# International Code Council

## **ICC A117.1-2015 edition** **Proposals received** **On the 2009 edition of the** **ICC A117.1 standard**

**For August 27-31, 2012 Meeting**

**A117.1 Proposed Change Matrix:  
July 27, 2012**

### 604.9.5, Figure 604.9.5, 609.5.1, 609.5.2

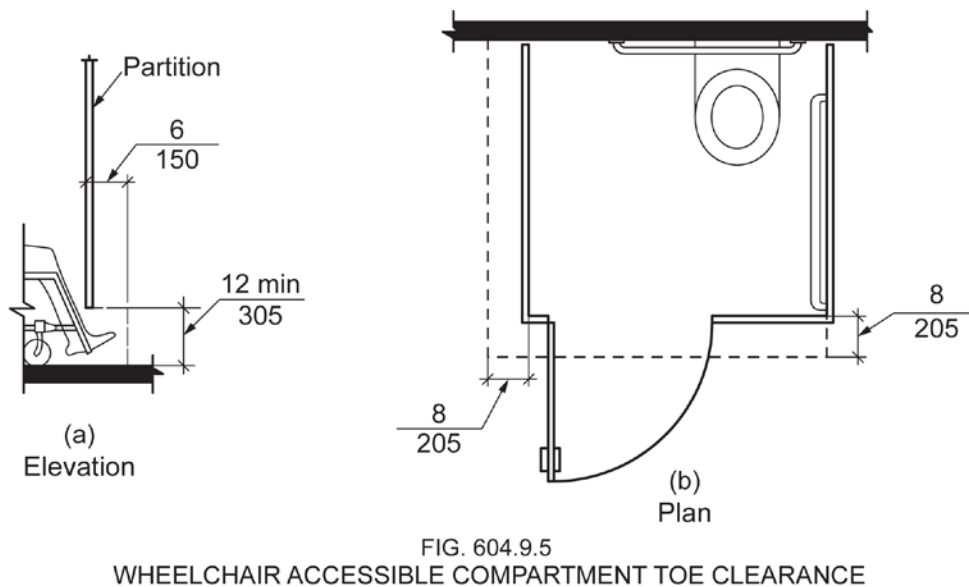
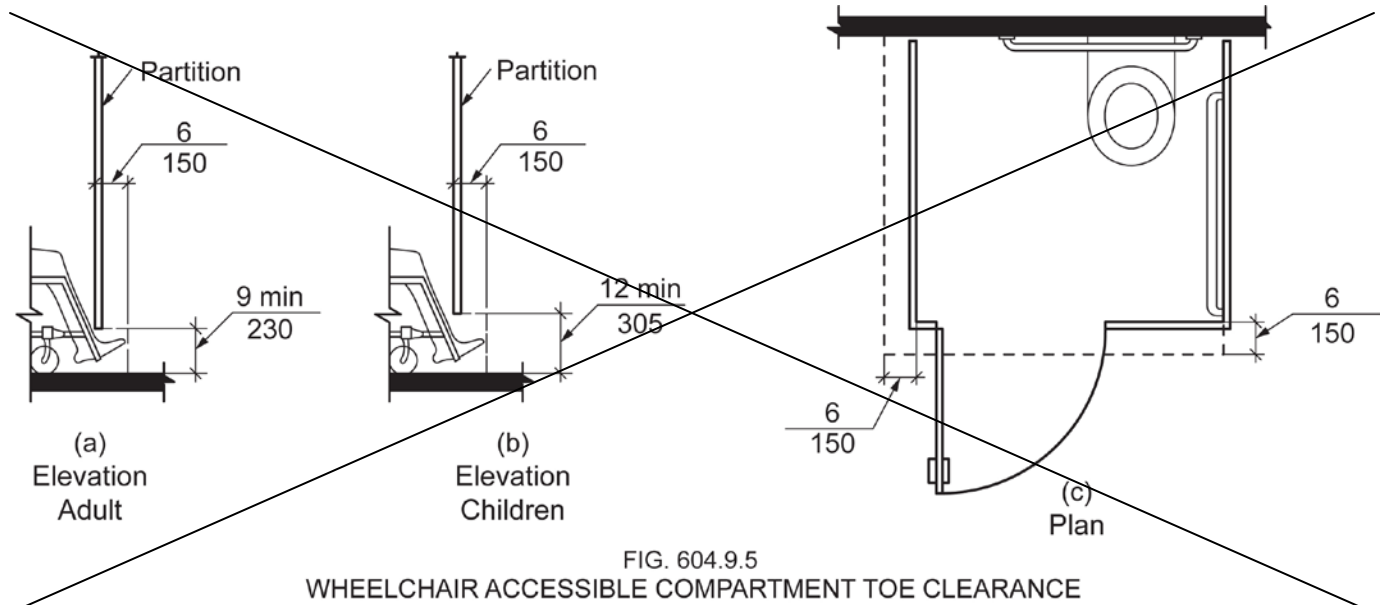
**604.9.5.1 Toe Clearance at Compartments.** ~~The front partition and at least one side partition of compartments shall provide a toe clearance of 9 12 inches (230 305 mm) minimum above the floor and extending 6 8 inches (150 205 mm) beyond the compartment side face of the partition, exclusive of partition support members.~~

These figures assume the wheelchair occupant is as far forward to the partition as possible but it does not account for the total occupied length of the device. Based on the existing ANSI standard, we propose that the exceptions be changed accordingly to account for the additional 2 inches of space added for toe clearance. This means that if an adjacent compartment does not have the requisite 8 inches, the accessible compartment must have 2 more inches than previously required in order to be exempted. Further, Steinfeld, et al., 2010 (pg. 95, fig. 4-5) notes that in order to allow 95% of power and manual wheelchair users to perform a 180-degree turn, a 67-inch width is necessary, which is consistent with the proposed change to the exemptions.

NOTE: This change necessitates a change to Fig. 604.9.5 to ensure consistency. Thus, the proposed revised figure has been attached, along with the existing figure for comparison purposes.

**Fig. 604.10**  
**Ambulatory Accessible Compartment**

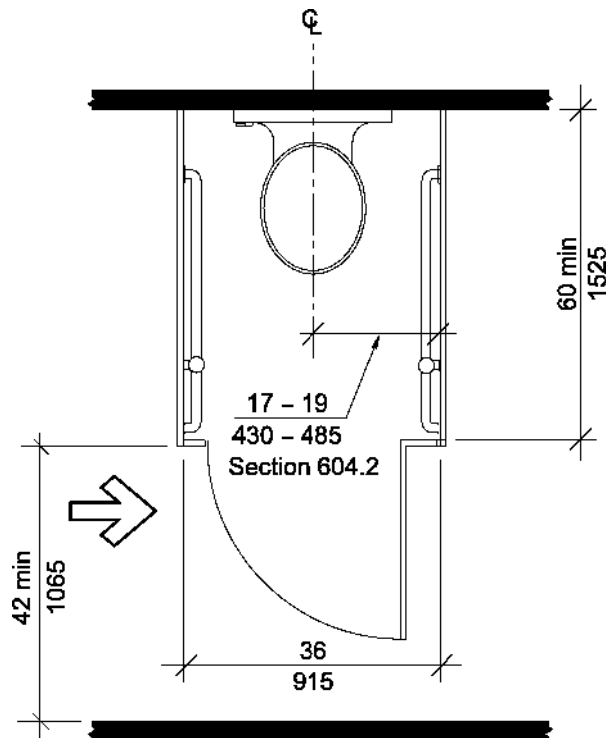
Change the called out dimension for the width of the compartment from ~~36 (915)~~ to 40 inches (1015)

**FIG. 607.2(b)**  
**CLEARANCE FOR BATHTUBS**

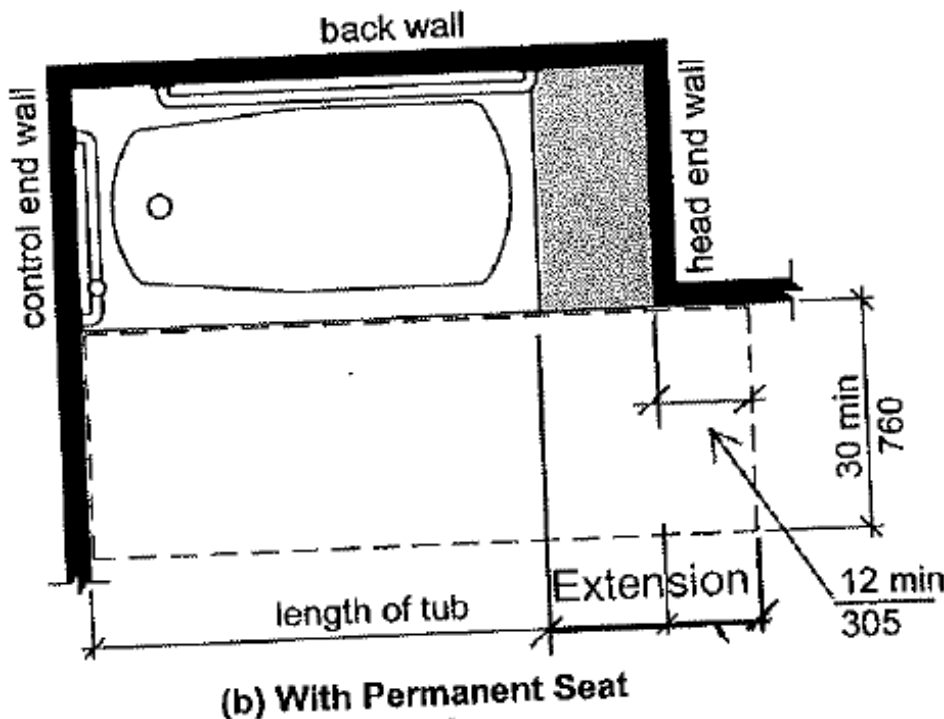
Section 607.4.1 sets the 'depth' of the seat. The current language skips the piece between the 'length of the tub' and the end of the extension. This is a technical issue that just gives you all the pieces. Please see graphic revision attached.

**607.2 Transfer Clearance.** A clearance in front of bathtubs extending the length of the bathtub and 30 inches minimum in depth shall be provided. Where a permanent seat is provided at the head end of the bathtub, the clearance shall extend 12 inches minimum beyond the wall at the head end of the bathtub.

**Fig. 608.4.3**  
**Alternate Roll-in-Type Combination Shower Control and Handshower Location**

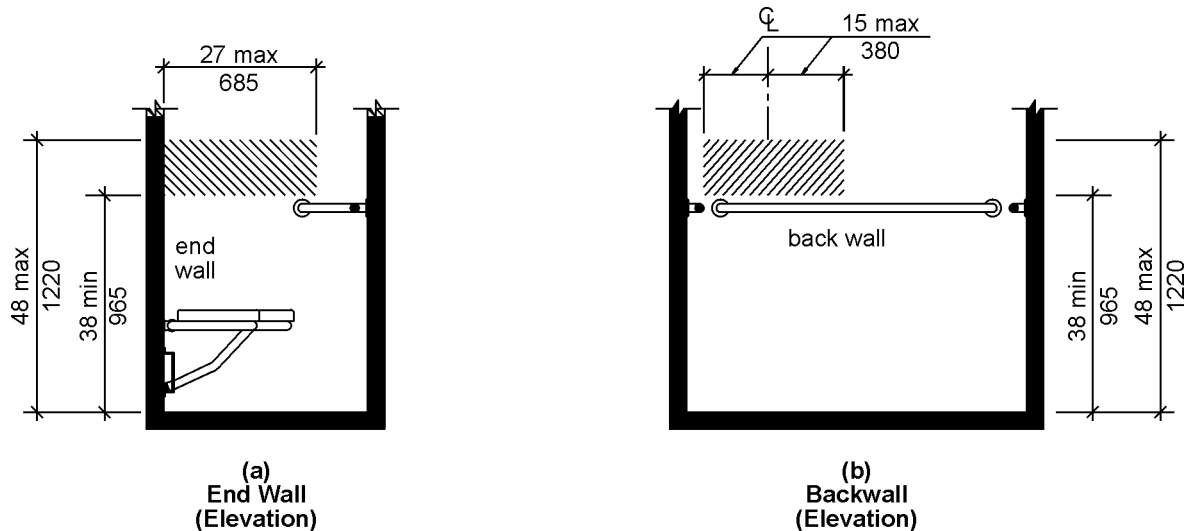
**608.4.3 Alternate Roll-in Combination Showers.** In alternate roll-in combination showers, the controls and hand shower shall be located 38 inches (965 mm) minimum and 48 inches (1220 mm) maximum above the shower floor. In alternate roll-in combination showers with controls and hand shower located on the end wall adjacent to the seat, the controls and hand shower shall be 27 inches (685 mm) maximum from the seat wall. In alternate roll-in combination showers with the controls and hand shower located on the back wall opposite the seat, the controls and hand shower shall be located within 15 inches (380 mm), left or right, of the centerline of the seat.

This change (or something similar) may be more appropriate in the scoping documents, but providing the revision in the A117.1 standard will help to clarify that there are truly three separate types of showers within the standard and provide further distinction between a standard roll-in shower and an alternate roll-in shower.

### 608.4.3, Figure 608.4.3

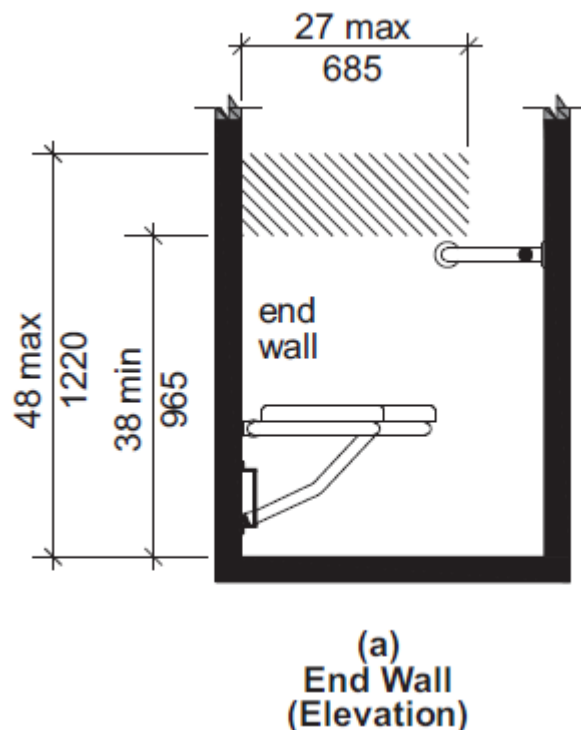
**Revise Figure 608.4.3 as follows:**

FIG. 610.2  
BATHTUB SEATS

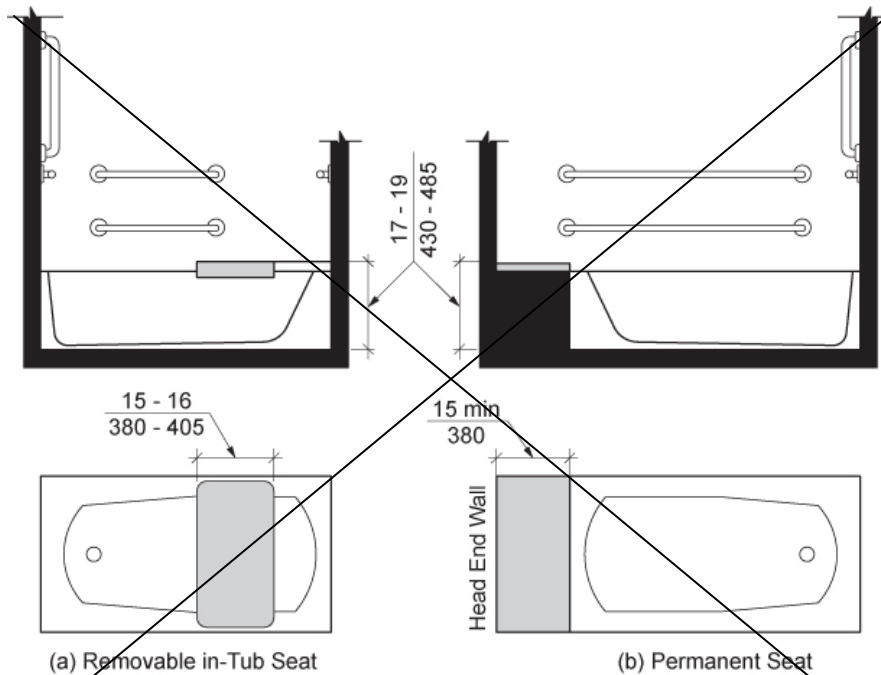
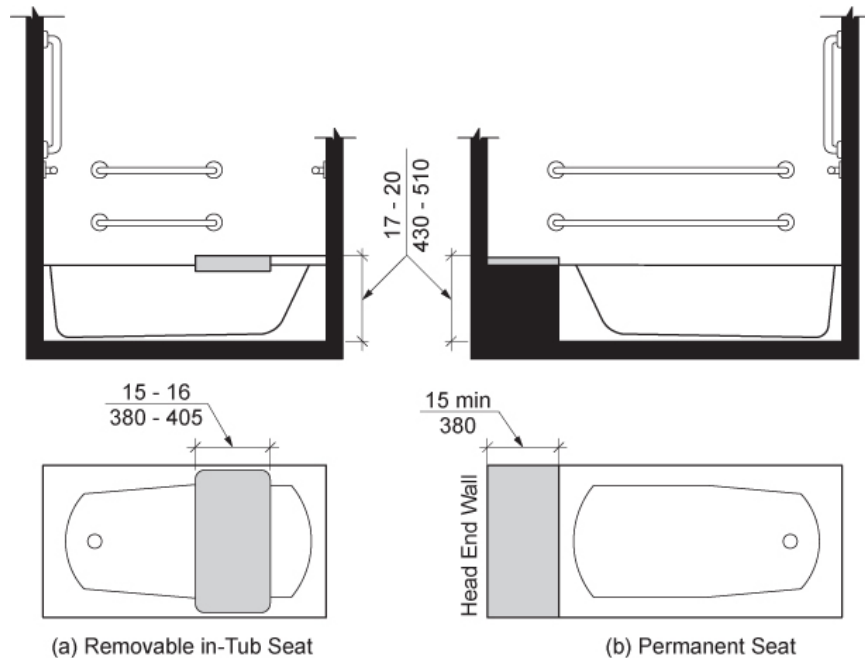
**EXCEPTION:** An accessible seat which is adjustable in height is permitted to provide adjustability within a range of 15 inches (380 mm) minimum to 25 inches (635 mm) maximum, provided that at least one adjustment setting provides a seat within the range specified in Section 610.2.

NOTE: This change necessitates a change to Fig. 610.2 to ensure consistency. Thus, the proposed revised figure has been attached, along with the existing figure for comparison purposes.

### 903.5, Figure 903

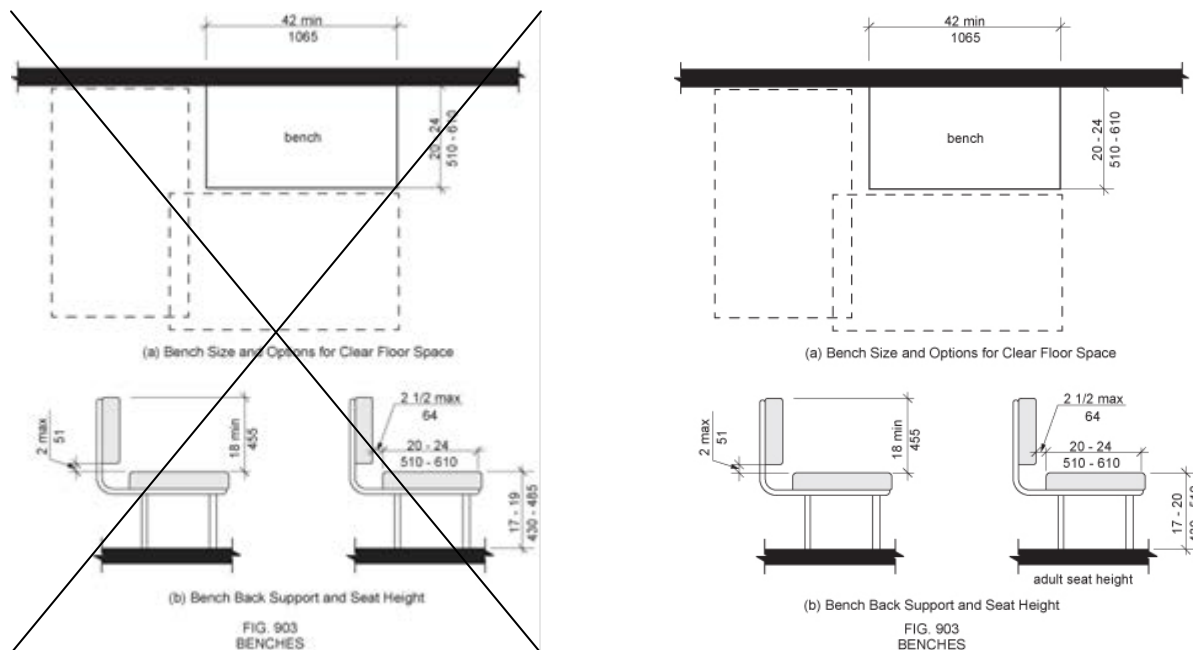
NOTE: This change necessitates a change to Fig. 903 to ensure consistency. Thus, the proposed revised figure has been attached, along with the existing figure for comparison purposes.
